ormerly 9331) Dr	EPARTML ( OF THE	ANAGEMENTE	r DD	NM-32311
		1 . 4 - 0 -	E O NM DOUTA	6 IF INDIAN, ALLOTTEE OR TRIBE NAM
SUNDRY	Y NOTICES AND R	REPORTS OF	1-WELLS	
(De not use this form	for proposals to drill or to de "APPLICATION FOR PERMI	leepen or plug back T" for such prop	sals.)

7. UNIT AGREEMENT NAME
OIL GAS WELL (X)	OTRES			
NAME OF OPERATOR	Uther -			8. FARM OR LEAST NAME
				Inexco Federal
McKay Oil Co	rporation		RECEIVED BY	9. WOLL NO.

- a 201	4. Roswell, New Me	exico 8820	2	1 FIELD AND POOL OR WILDCAT
LOCATION OF WELL SEPTOT	t location clearly and in accor	dance with any St	te reliable ental 1887	, <b>U</b> , <b>A</b> ·
See also space 17 below.) At surface				W. Pecos Slope-Abo
1980'	FWL & 1980' FSL	1	O. C. D.	SURVEY OR AREA
1004	•	I	ARTESIA, OFFICE	Sec. 30, T5S, R22E
	· · · · · · · · · · · · · · · · · · ·	al Liberton	CR MC 1	12. COUNTY OR PARISH 13. STATE
PERMIT NO.	15 ELEVATIONS (	Show whether DF, R	1, GR. EU./	Chaves N.M.
		4243' GR		
	Check Appropriate Box	To Indicate Na	ture of Notice, Report,	or Other Data
	CE OF INTENTION TO:	:	9:	BREQUENT REPORT OF
8011		,	WATER SHUT-OFF	REPAIRING WELL
TEST WATER SHUT-OFF	Prit or ALTES (A)		FRACTUBE TREATMENT	ALTERING CASING
PR

Figure la: Location of corrected proposed access road reroute to Inexco Fed. #1.

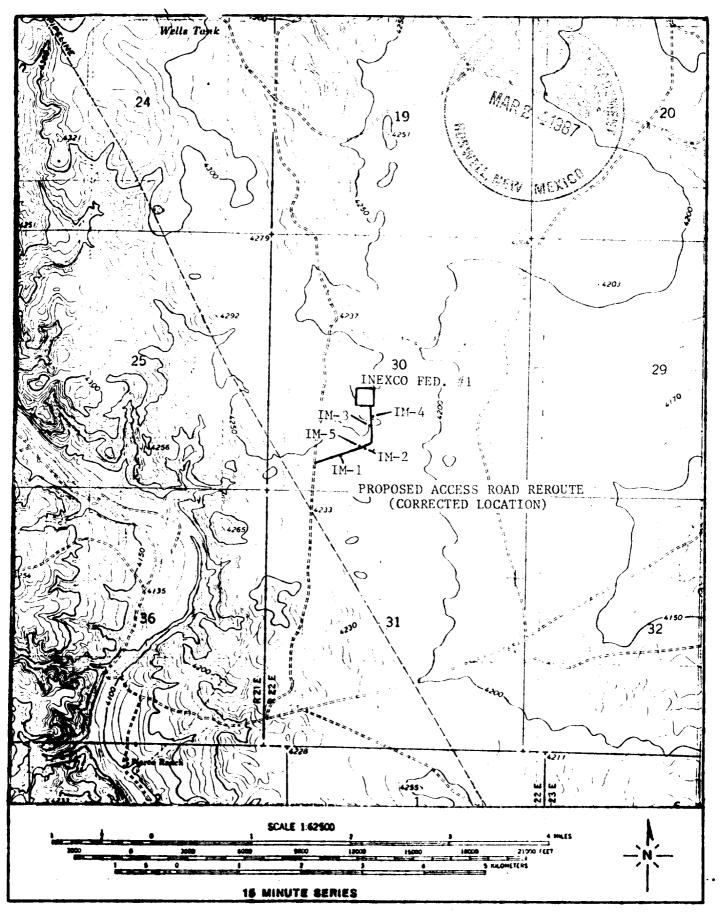
Operator prassing displaye route due to this work.)  Operator prassing displaye route due to the archaeol under report Caliche pit Corn.	oposes to construct don the enclosed of an archaeological survey was t #F87-146.  for pad and access to the foregoing lattice and correct the	et an access topographic conducted c	details and give pertinent is and measured and true is and measured and true is map. The proposite original accesson the proposed at 14 Sec. 17, P6s,	dates, including estimated date of starting vertical depths for all markers and zones to approximately 1900 in esed access road is a resess road.  access road by ACA-ENMU,  RESE, private, Bronson
